ATTACHMENT 2 TO AEP:NRC:0860

REVISED PAGES WHICH THE  
TECHNICAL SPECIFICATION CHANGES  
FOR DONALD C. COOK NUCLEAR PLANT  
UNIT NO. 2 CYCLE 5

FIGURE 3.2-4 RCS TOTAL FLOWRATE VERSUS R - FOUR LOOPS IN OPERATION

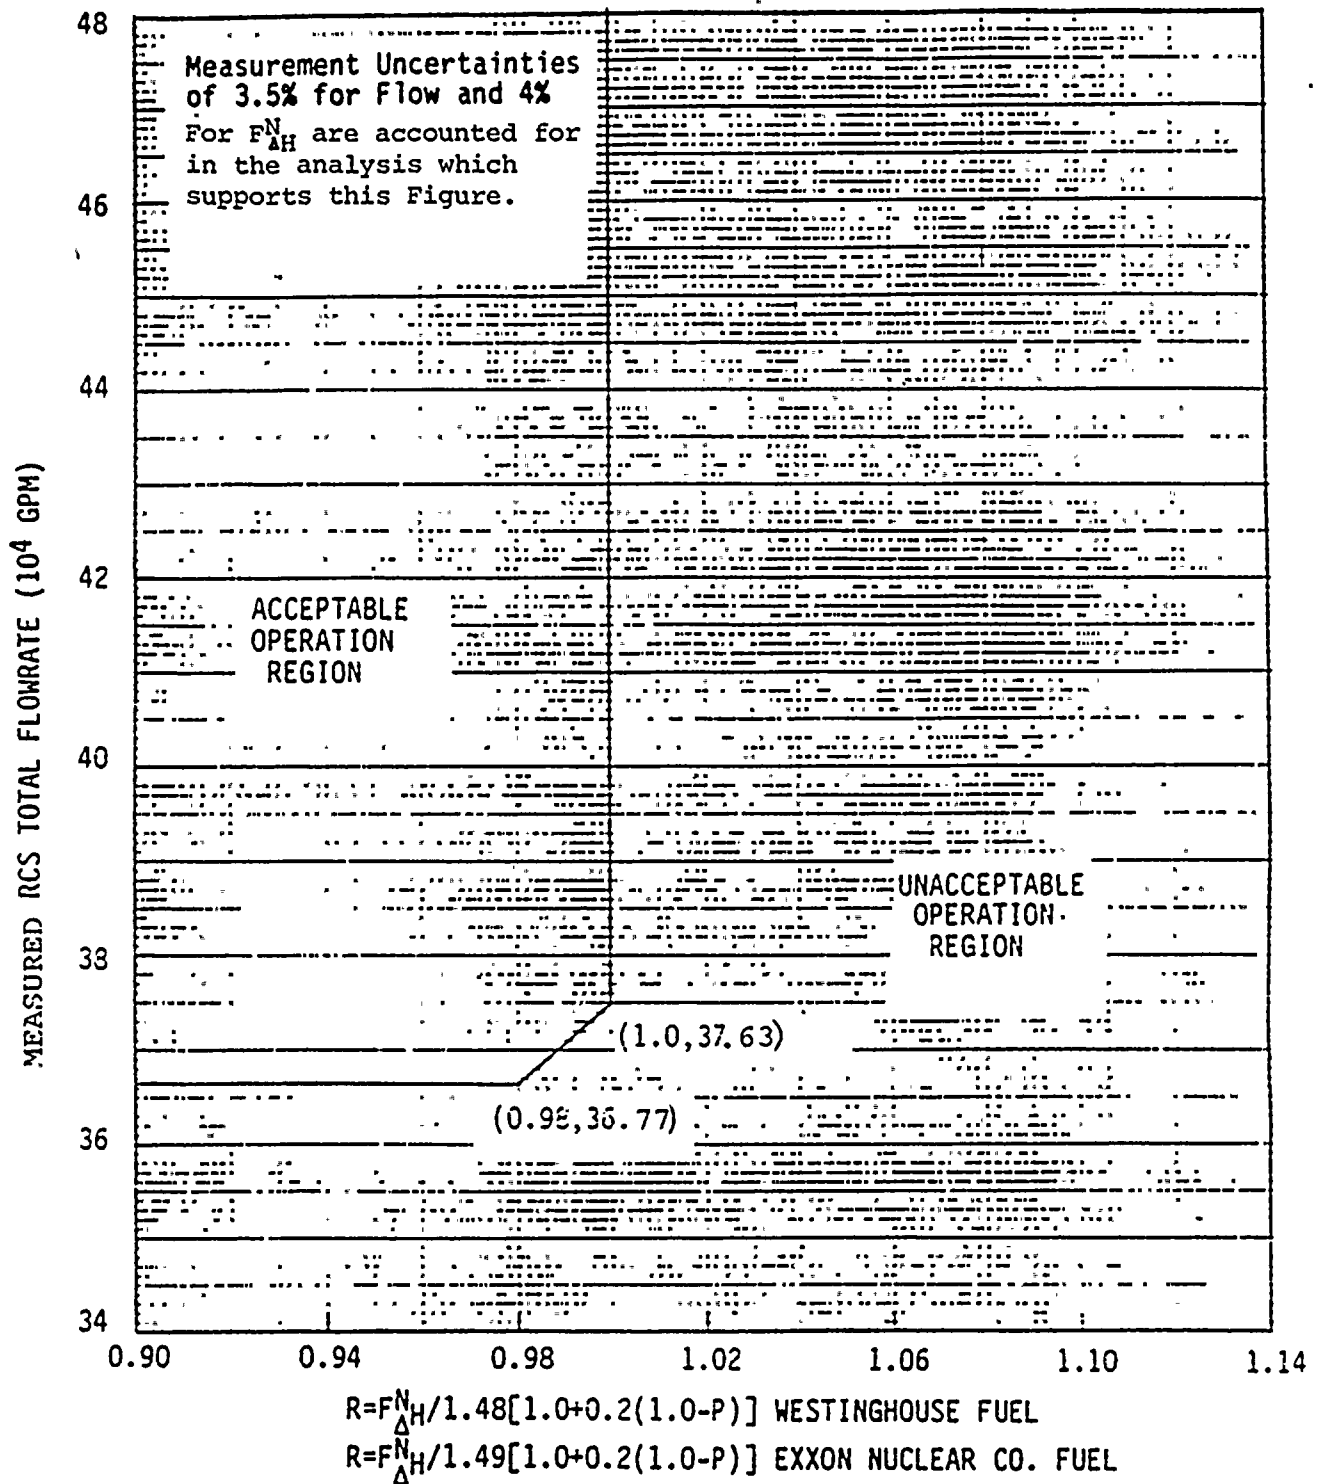
$$R = F_{NH}^N / 1.48 [1.0 + 0.2(1.0 - P)] \text{ WESTINGHOUSE FUEL}$$

$$R = F_{NH}^N / 1.49 [1.0 + 0.2(1.0 - P)] \text{ EXXON NUCLEAR CO. FUEL}$$

$F_{\Delta H}^N$  will be maintained within its limits provided conditions a. through d. above are maintained. As noted on Figures 3.2-4 and 3.2-5, RCS flow rate and  $F_{\Delta H}^N$  may be "traded off" against one another (i.e., a low measured RCS flow rate is acceptable if the measured  $F_{\Delta H}^N$  is also low) to ensure that the calculated DNBR will not be below the design DNBR value. The  $F_{\Delta H}$  limit in combination with the  $F_Q$  limit of 2.04 ensures compliance with the ECCS acceptance criteria. The relaxation of  $F_{\Delta H}^N$  as a function of THERMAL POWER allows changes in the radial power shape for all permissible rod insertion limits.

When RCS flow rate and  $F_{\Delta H}^N$  are measured, no additional allowances are necessary prior to comparison with the limits of Figures 3.2-4 and 3.2-5. Measurement errors of 3.5% for RCS flow total flow rate and 4% for  $F_{\Delta H}^N$  have been allowed for in determination of the design DNBR value. Measurement error of 4% for  $F_{\Delta H}$  has been allowed for in determination of the ECCS limits.
